**THE GARDENS AT NORTH
CAREFREE
PRELIMINARY DRAINAGE REPORT
EL PASO COUNTY, COLORADO**

PUDSP-18-004

August 3, 2018

DETENTION BASIN STAGE-STORAGE TABLE BUILDER

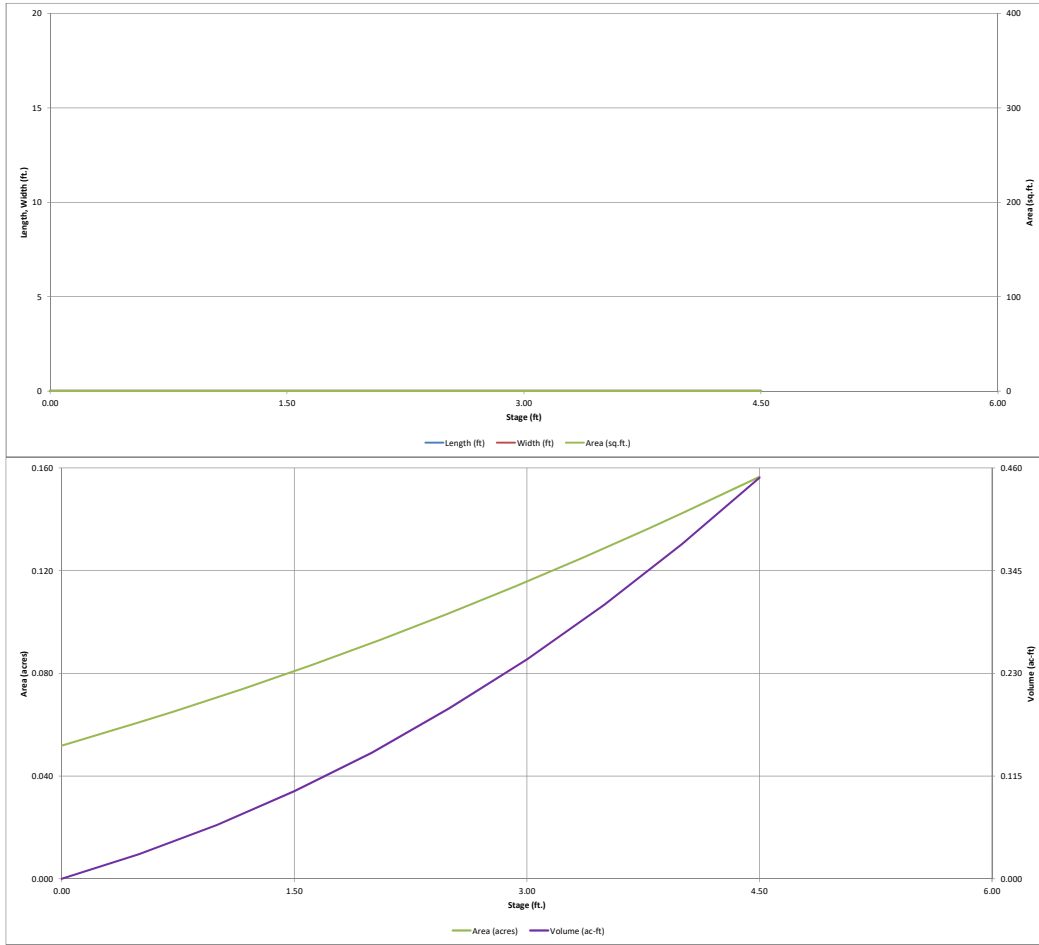
Since improvements downstream has not been fully constructed provide Full Spectrum Detention (FSD) per current narrative. Update the narrative accordingly.

Figure 3: Proposed Drainage Map

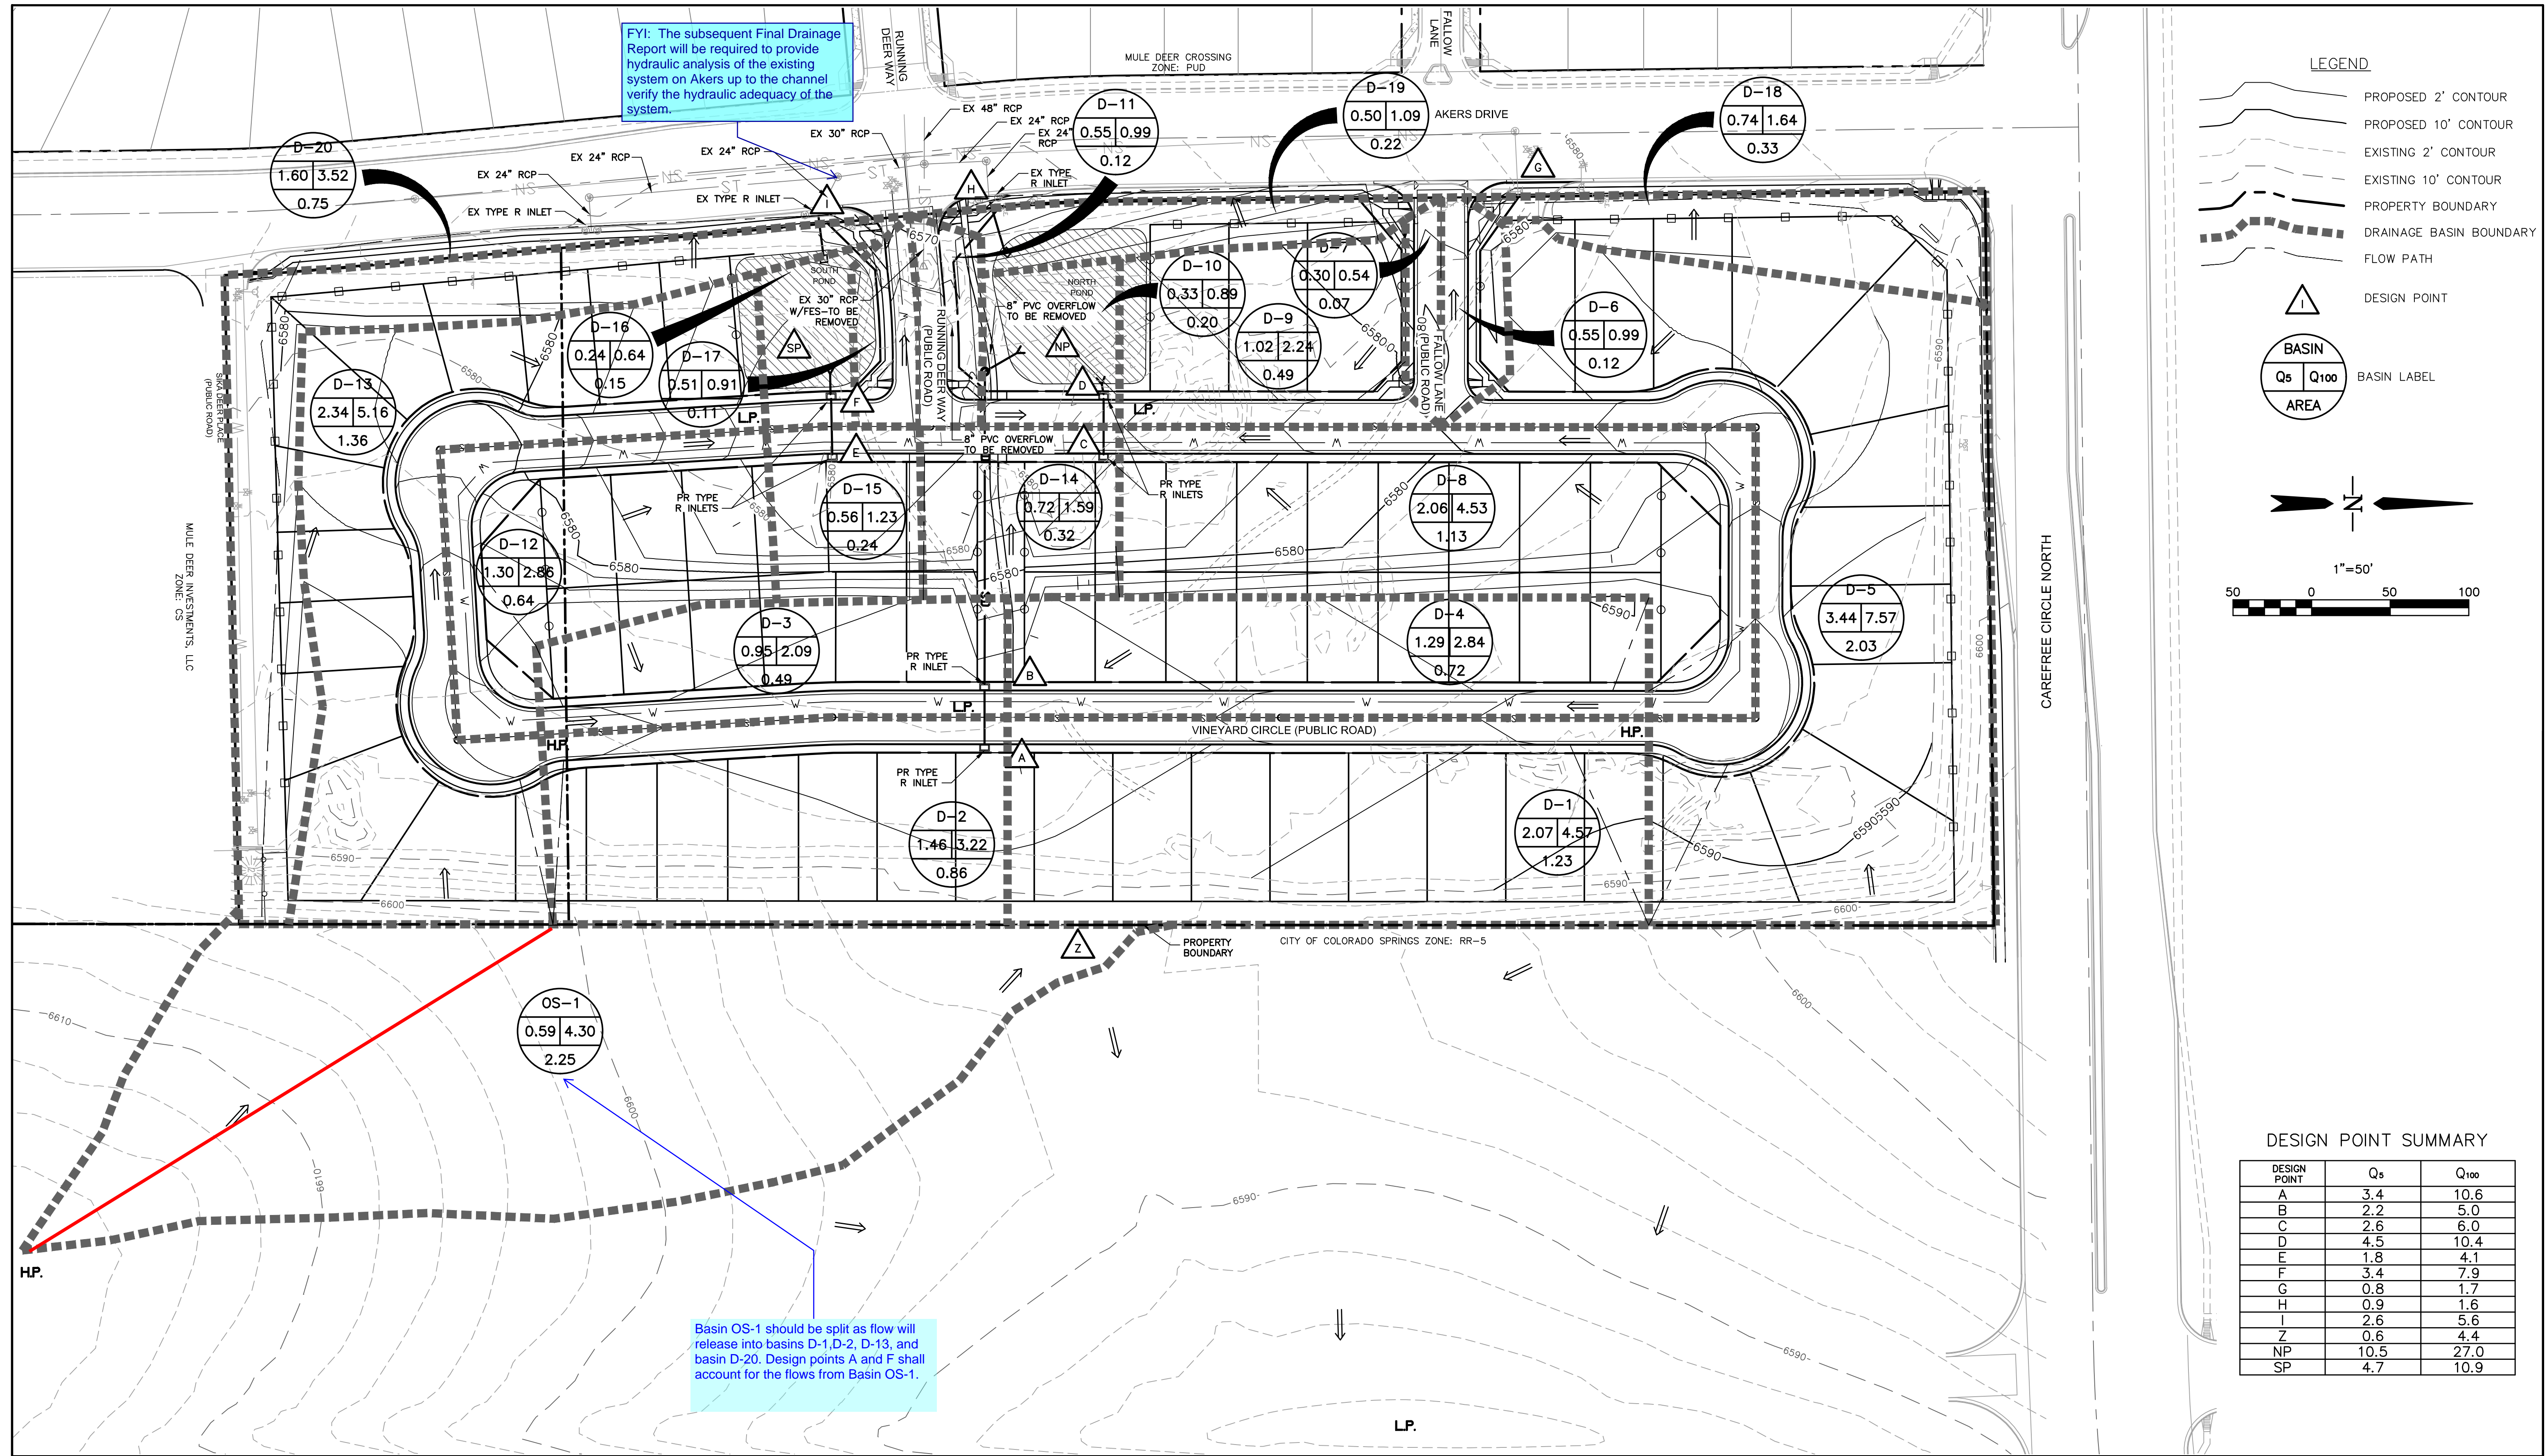
FYI: The subsequent Final Drainage Report will be required to provide hydraulic analysis of the existing system on Akers up to the channel verify the hydraulic adequacy of the system.
